## **ALEXANDER PLACE SUBDIVISION**

The plat illustrates the proposed 0.5±-acre, 2-lot subdivision which is located on the southeast corner of Airport Boulevard and Mayflower Street and is within Council District 5.

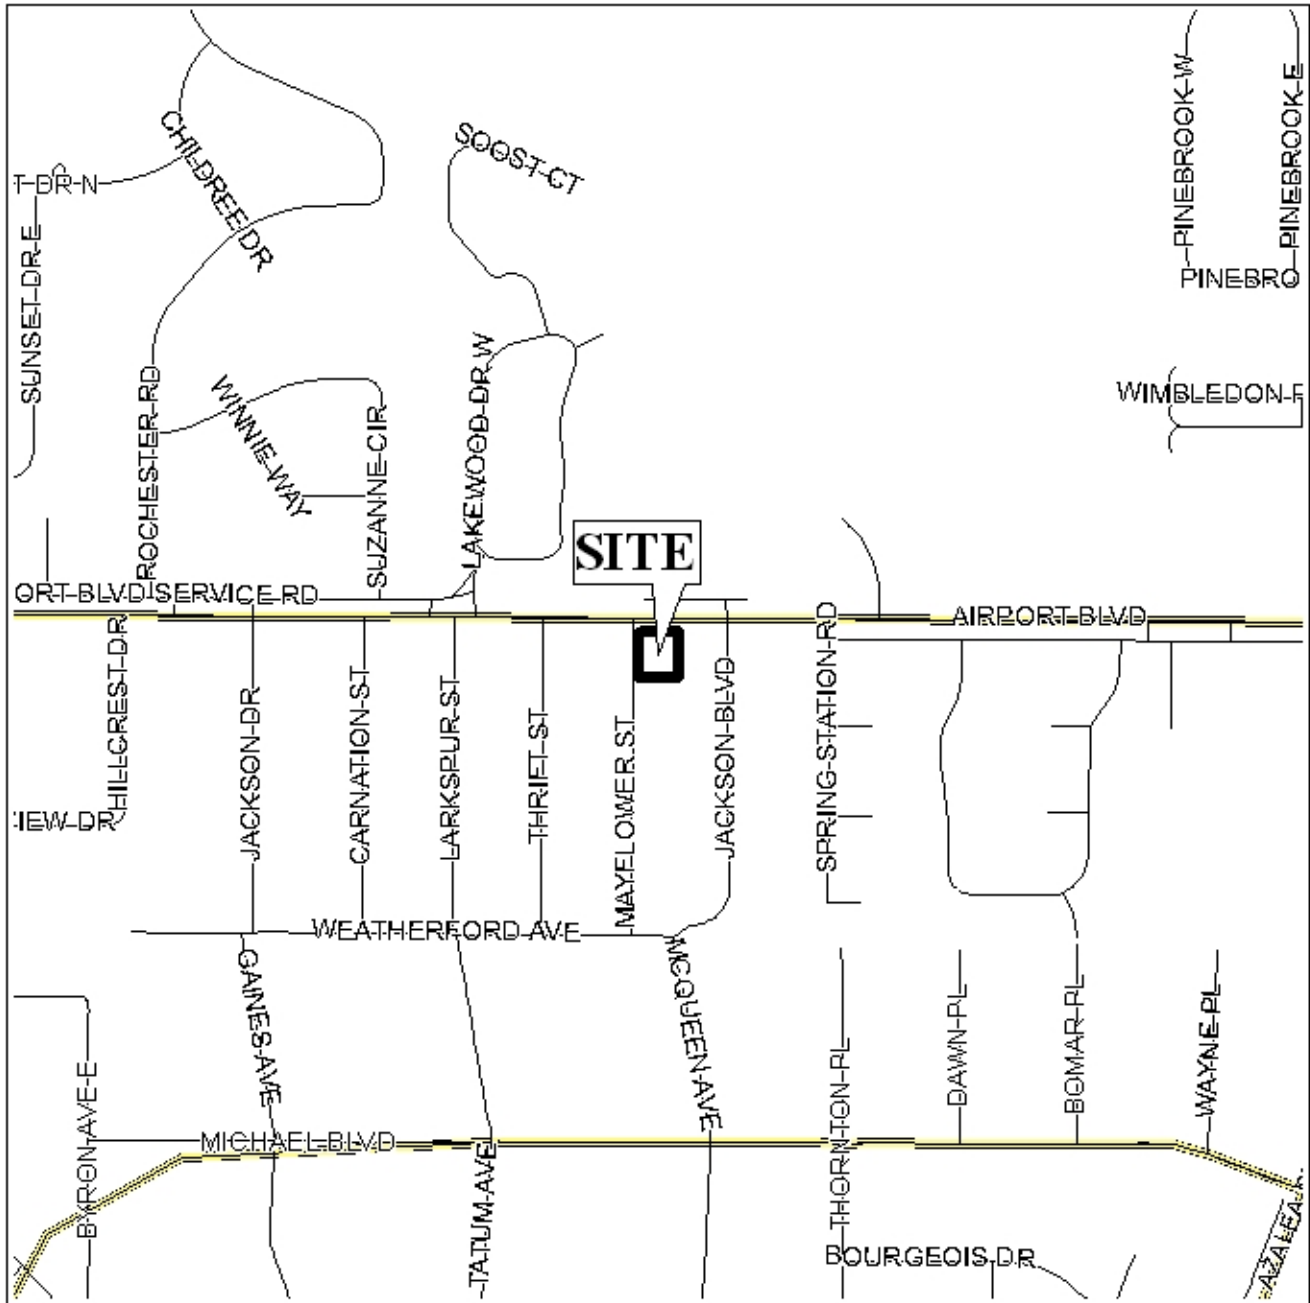
The purpose of this application is to create two lots of records from three parcels and a portion of a fourth parcel. It is recommended that the application be revised to include all parcels, and that the request be revised to create a three-lot subdivision, with remainder of Lot 7 be included with Lot 8, Block B, Mayfair Hills Subdivision being the third lot.

Access management is a concern due to Airport Boulevard being a proposed major street. It is recommended that the development be denied access onto Airport Boulevard; each lot is limited to one curb cut onto Mayflower Street, with the size, design and location to be approved by the Traffic Engineering Department.

As shown on the preliminary plat, Lot 1 is substandard in size. However, it is in its original size and configuration. Over the years, multiple lots and a portion of a lot (Lot 7) have been amassed into one parcel without the benefit of Planning Commission approval. Therefore, a waiver of V.D.2 and V.D.3 would be required to allow the recreation of the substandard lot; and the remainder of the partial parcel (Lot 7) and the lot into which it has been incorporated (Lot 8) should be included in the subdivision.

The final plat should illustrate the 25-foot minimum building setback as measured from the property line.

Based upon the preceding, the plat is recommended for Holdover until the September 7<sup>th</sup> meeting, to allow the following to be submitted by August 21<sup>st</sup>: 1) revision of the application to include the remainder of Lot 7 and Lot 8 to the South; 2) revision of the application to create a three-lot subdivision; 3) the placement of a note on the Final Plat denying access onto Airport Boulevard; and 4) the placement of the 25-foot minimum building setback lines on the final plat.

*The plat is recommended for Denial for the following reasons: 1) the applicant did not include the remainder of Lot 7 and lot 8 to the South; 2) revision of the application to create a three-lot subdivision; 3) the placement of a note on the Final Plat denying access onto Airport Boulevard; and 4) the placement of the 25-foot minimum building setback lines on the final plat*
